HISTORIC AND DESIGN REVIEW COMMISSION

HDRC CASE NO: 2024-362
COMMON NAME: Approx. 9501 SE Loop 410
LEGAL DESCRIPTION: NCB 10917 P-205 (18.90 AC)
ZONING: IDZ-2, H
CITY COUNCIL DIST.: 3
DISTRICT: Mission Historic District
APPLICANT: Goef Edwards/Alta Architects
OWNER: SABOT DEVELOPMENT LTD
TYPE OF WORK: Construction of two, three story, multi-family residential structures, site and landscaping work
APPLICATION RECEIVED: October 21, 2024
60-DAY REVIEW: December 20, 2024
CASE MANAGER: Edward Hall

REQUEST:

Historic and Design Review Commission
Design Review Committee Report

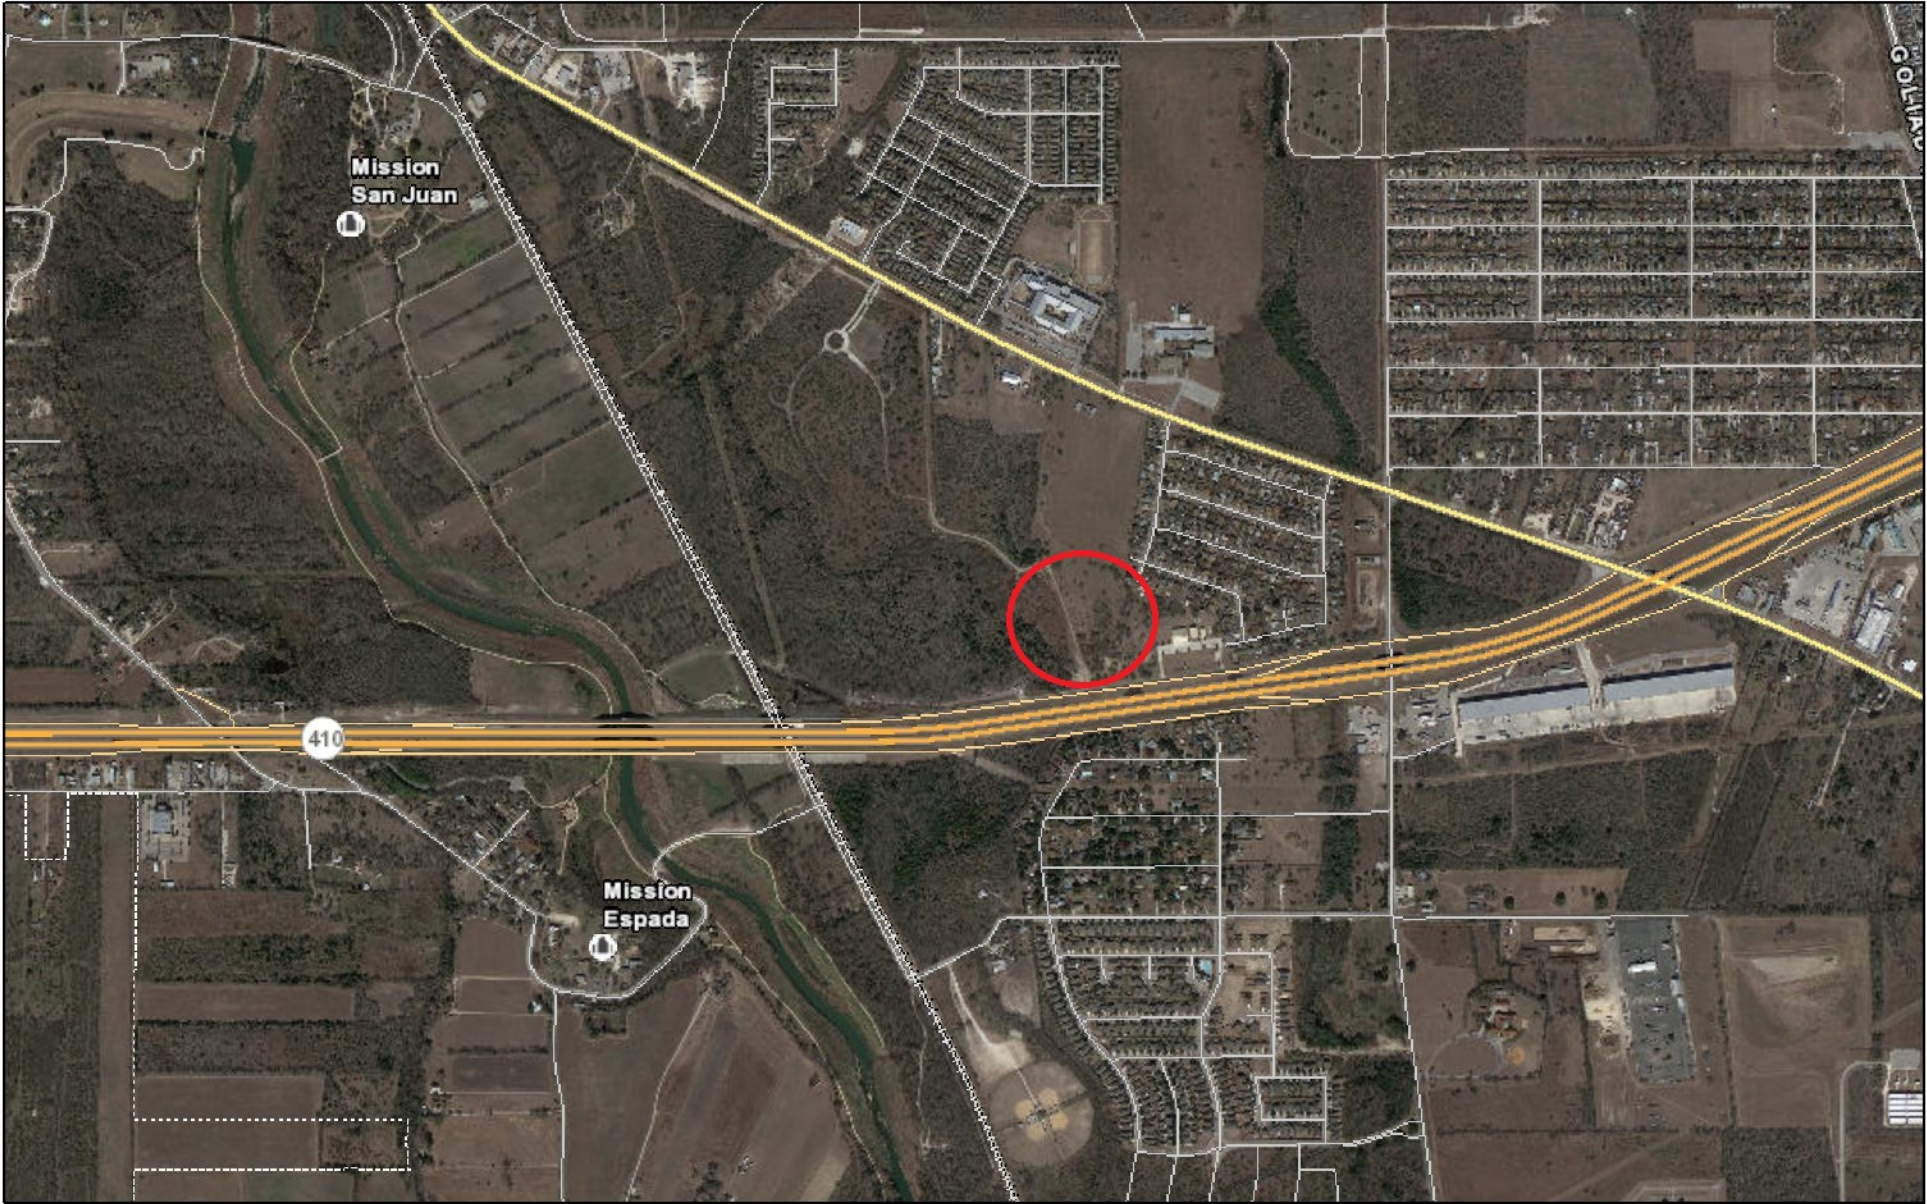
JF: Questions regarding roof form. MV: Roofs will be pitched.

MS: Questions about window materials. MV: Windows will be vinyl and will be inset within openings two inches.
